RE: TRUGLO Inc. Exempt Distribution License Renewal Application License No. 42-23889-01E

Enclosed are our responses to your questions contained in your emailed dated July 7, 2022. For your convenience we have listed your questions with our response:

Figure 1. Beta particle range-energy curve showing threshold energies for shallow (7 g/cm<sup>2</sup>), lens or eye (300 mg/cm<sup>2</sup>) and deep (1000 mg/cm<sup>2</sup>) dose equivalents

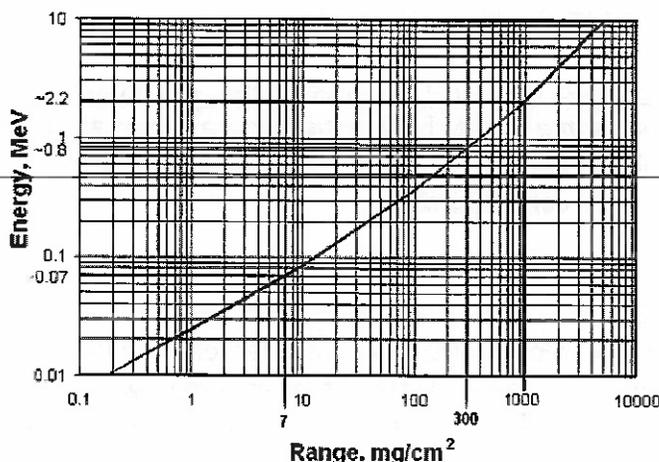
For the routine user of a single exempt unit, the probability is low that the containment could be compromised as described in question c). The following dose assessment is made to determine the expected dose from the routine use of the TRUGLO gun sight to ensure that doses are below the limits given in Columns III and IV of the table in 10 CFR 32.24. The potential dose from the particle radiation and the photon radiation components of H-3 decay are examined.

Tritium decays to stable Helium-3 (He-3) by emitting a negative beta particle. No direct photon (gamma) radiation occurs during this transformation. The  $E_{\max}$  energy of this beta particle is 0.0186 MeV (18.6 keV) and the  $E_{\text{avg}}$  energy is 0.005685 MeV (5.69 keV) (Kocher, David C. "Radioactive Decay Data Tables." U.S. Department of Energy, DOE/TIC-11026). The yield of this transformation is 1.0. Inspection of the Beta Particle Range-Energy Curve from the Health Physics and Radiological Health Handbook shows that a H-3 beta particle, even at the maximum particle energy (with a yield approaching zero) will not penetrate a density-thickness of 7 mg/cm<sup>2</sup> (the nominal density-thickness of the upper layer of the epidermis (the stratum corneum or dead skin cell layer)). Therefore, as an external hazard, there would be no shallow dose (SDE), no eye (lens) dose (LDE), and no deep dose (DDE) delivered to any person from the H-3 particle emissions.

With regards to routine use, external radiation dose to all exposed individuals and groups is zero. Internal doses, at a leak rate of 10 ppb/h, should be negligible and certainly less than 1 mrem per year for an individual and less than 10 mrem per year to handlers and distributors of these devices. This fulfills the requirements of 10 CFR 32.23 and 10 CFR 32.24 for external whole-body doses, extremities and skin. Therefore, in normal use of a single exempt unit, it is unlikely that the external radiation dose in any one year, or the dose commitment resulting from the intake of radioactive material in any one year, to a suitable sample of the group of individuals expected to be most highly exposed to radiation or radioactive material from the product will exceed 1 mrem.
